8.7 Individual(s) Comments and Responses

- 8.7.1 Michael Baer
- 8.7.2 David Beech
 - David Beech – Letter 1
 - David Beech – Letter 2
 - David Beech – Letter 3
 - David Beech – Letter 4
 - David Beech – Letter 5

PROCUREMENT, 1. Source Water Slant Wells RFP, Contract Drawings. The converted test well is seen slanting down from top center, labelled EXISTING TEST SLANT WELL (STAND-BY 1).

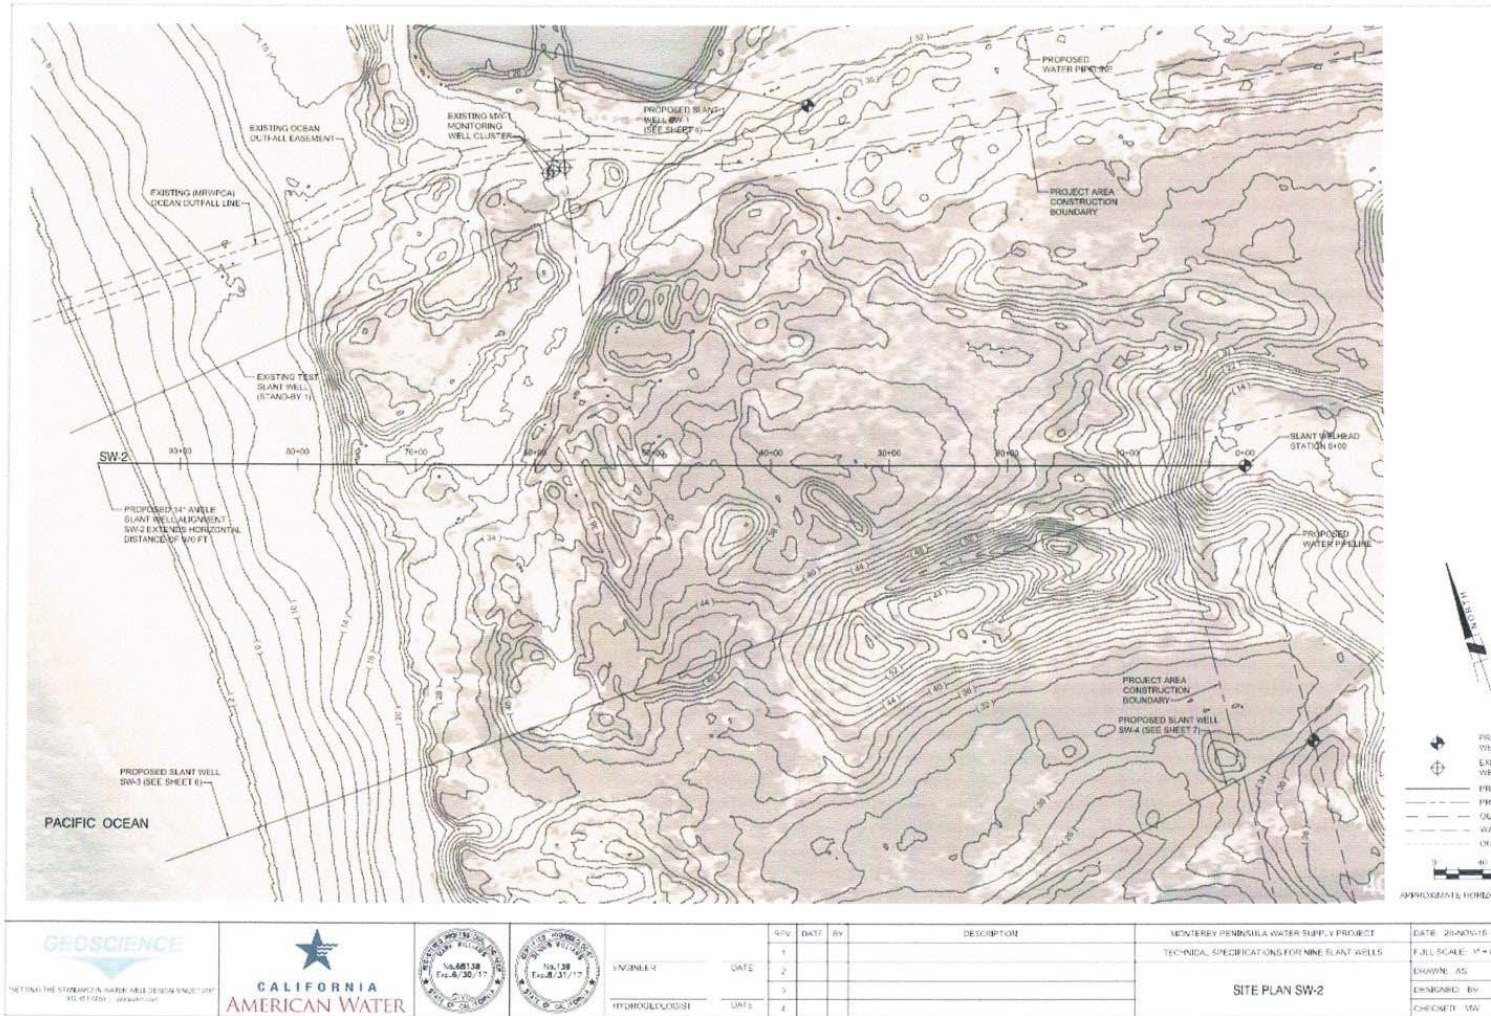
This letter is to notify you formally of an apparent permit violation concerning the decommissioning of the Cal-Am Test Slant Well, whose Permit \was approved at the CCC November 2014 meeting, and revised in October, 2015, after a halt in testing. The issue only came to my attention by accident in January when I was researching the facts on the slant well project to present at an informational community outreach meeting in Carmel, and looked at the map for the intended production system.

Cal-Am has subsequently issued an RFP for construction of the production wells (ahead of approval of the test results), where the test well was explicitly allowed to be “converted into a production well.” A bid from Boart Longyear was accepted, including use of the test well as a backup well in the production system. The map below is taken from the official documentation of the project at <http://www.watersupply.org> under

The first illustration I encountered was Exhibit 3 of the package that Commissioners would have seen in deciding the Appeal and granting the test well permit in November 2014.

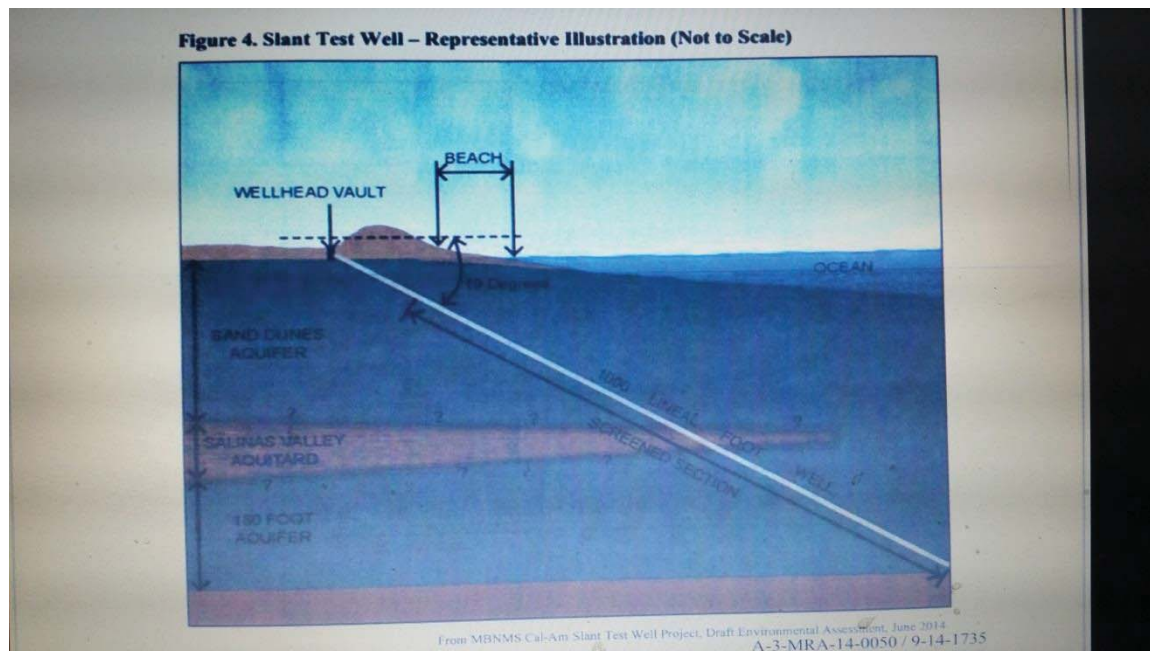
This gives an immediate impression that the well extends way under the OCEAN as it says (barely legibly, even in the original – see <http://documents.coastal.ca.gov/reports/2014/11/W14a-s-11-2014.pdf>). This illustration, besides being “Not to Scale”, was not kept up to date with the text of the permit, so it says along the well bore “1000 LINEAL FEET”, and, given the position of the original WELLHEAD VAULT at 450 feet inland from mean sea level, the well length is exaggerated to look as though it is over 2000 feet. This would not matter so much were it not for the fact that most of the Coastal

Commissioners, with their almost impossible reading load, would have formed their main impression from this picture. Probably most CalAm customers still think this is roughly the slant well that is being tested – it was only a few months ago that I personally began to discover that it was not.

EXHIBIT 2

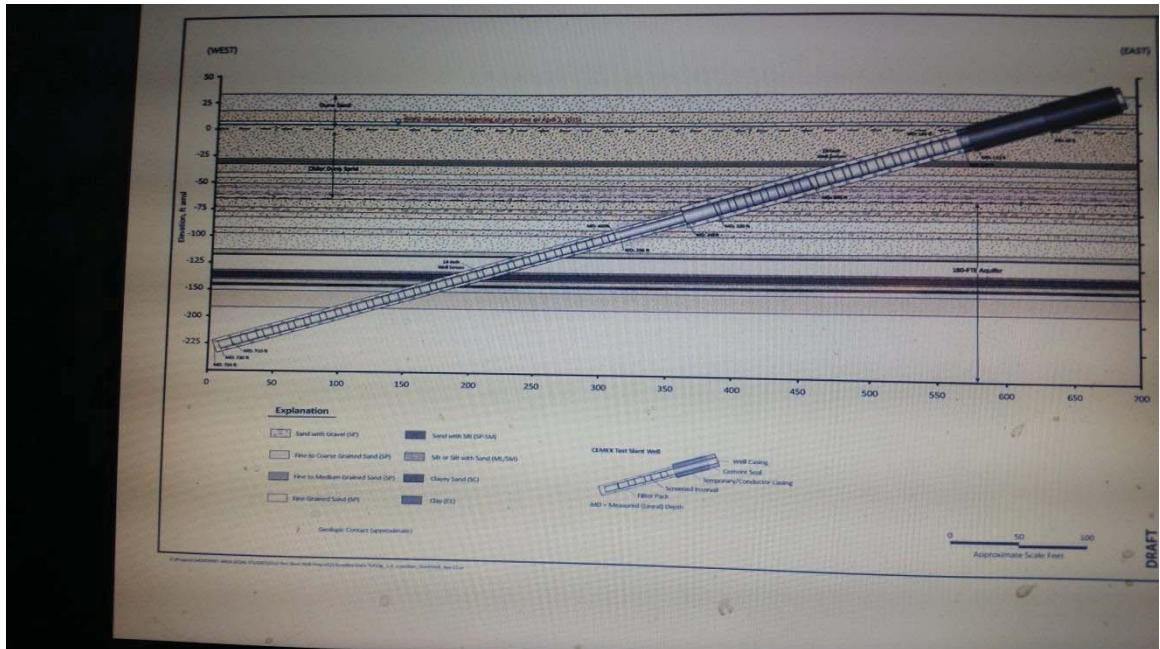
Seen in cross-section, the actual test well is shown below:

Note that the horizontal length of the well is shown as less than 700 feet, consistent with the following calculation:

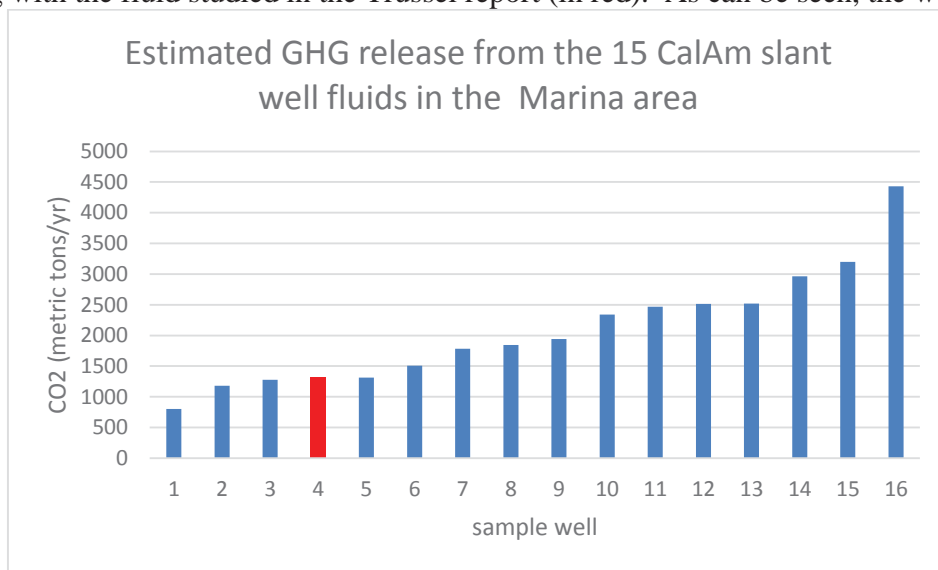
- In the Trussel report the well fluid composition used to compute the “worst-case” carbon dioxide release is not representative of fluids sampled to date and in fact is nearly the “best-case” scenario

The well fluid composition used in the Trussel report to compute carbon dioxide release is not representative of the carbon dioxide gas contents of the 15 wells sampled to date in the Marina area as part of the CalAm project. Figure 1 below shows my estimated carbon dioxide release rates along with the fluid studied in the Trussel report (in red). As can be seen, the well fluid

Figure 3 Time for Slant Well to Pull 96% Seawater (GeoScience 2014b).

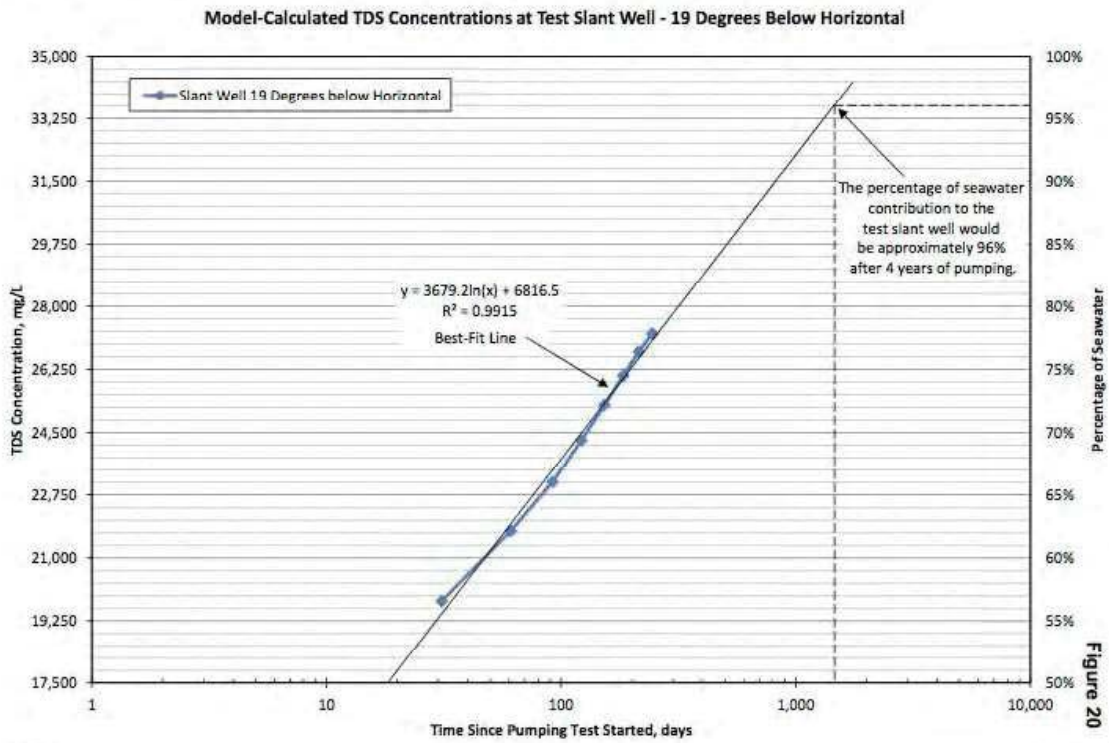
This chart is generated from the data found in the Monterey Peninsula Water Supply Project Test Slant Well Long Term Pumping Test Monitoring Report No. 97 which is found on the website <http://www.watersupplyproject.org/#!test-well/c1f1l>, which, in turn, is briefly mentioned on page 4.4-42 of the CALAM MONTEREY PENINSULA WATER SUPPLY PROJECT Draft Environmental Impact Report/Environmental Impact Statement.

- Further evidence that the test slant well has caused seawater intrusion into the 180/400 Sub-basin is provided by Figure 3 below, extracted from the GeoScience 2014b report in the appendices to the DEIR/DEIS.

Moore-2 Figure 3 from Geoscience 2014b, as cited in EIR/EIS Appendix G2, presents modeled results of the anticipated salinity at the test slant well over time and therefore in the capture zone; it does not illustrate observed results of the test slant well, nor does it provide evidence of increased seawater intrusion. The graph shows how many days are expected to elapse, from the start of pumping, before the test slant well would capture 96 percent seawater. It is not accurate to consider this evidence of seawater intrusion in the 180 and 400-Foot Aquifers. In addition, the test well was not operating until 2015, after the release of the referenced Geoscience 2014 report. As stated in response to comment Moore-1, as the highly brackish, ambient groundwater would be extracted by the slant wells, seawater would recharge the capture zone and the percentage of seawater would increase. The slant wells would capture seawater that would otherwise flow inland, thereby reducing the potential for seawater intrusion inland of the capture zone. See Master Response 8, Section 8.2.8.1 for a description of the hydrogeologic characteristics of the feedwater capture zone. No significant impact on groundwater quality has been observed as a result of test slant well operation.
